To: T10 Committee (SCSI)

Subject: SAS: SP_DWS Wording Changes

There has been confusion about how primitives and data dwords are handled in the SP_DWS state machine. This proposal fixes that.

Figure 1 — SP_DWS (phy layer dword synchronization) state machine

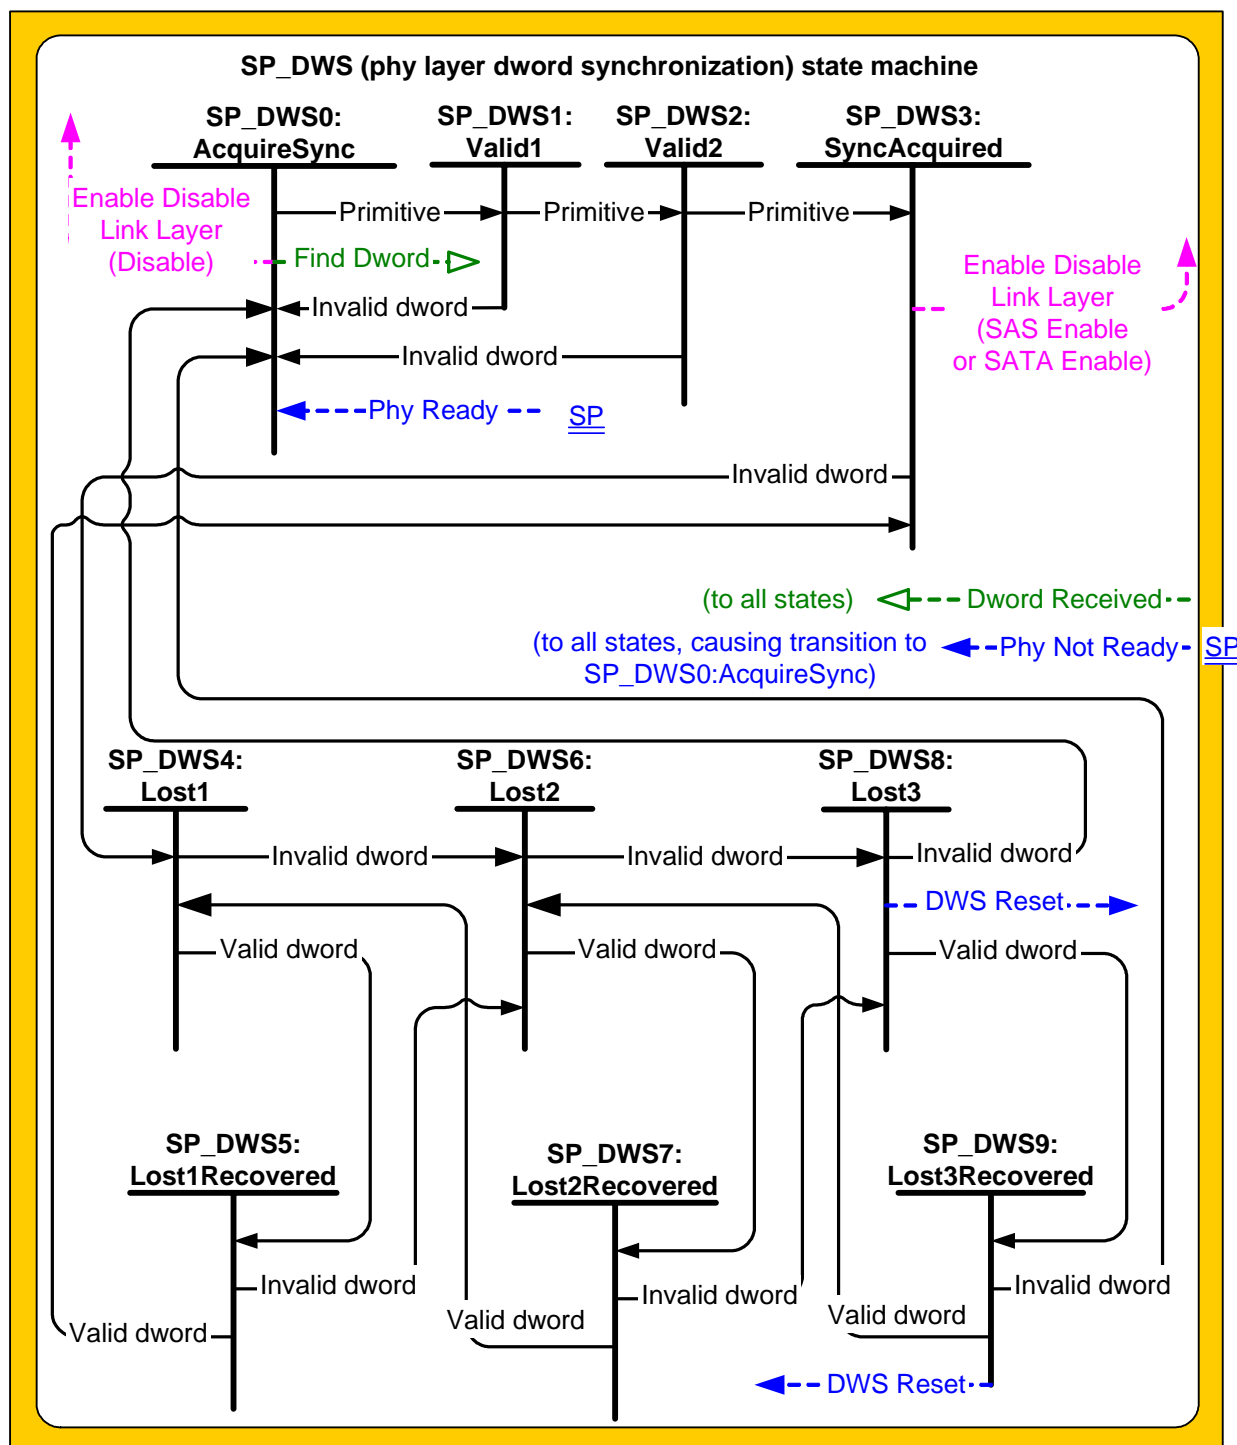
This state machine receives the following ~~parameters~~messages from the SP state machine (see 6.7):

This state machine sends the following ~~parameters~~messages to the SP state machine:

- Dword Received (~~Valid~~Valid Primitive); and

- b) Dword Received (~~Invalid~~Valid Dword): ~~and~~
- c) Dword Received (Invalid).

- a) send a Dword Received (Valid Primitive) message to the SP_DWS state machine anytime a dword is received that contains a K28.5 character in the first byte position followed by three data characters;
- b) send a Dword Received (Invalid) message to the SP_DWS state machine anytime an invalid dword (see 3.1.61xx) is received; or
- c) send a Dword Received (Valid Dword) message to the SP_DWS state machine anytime a data dword is received.
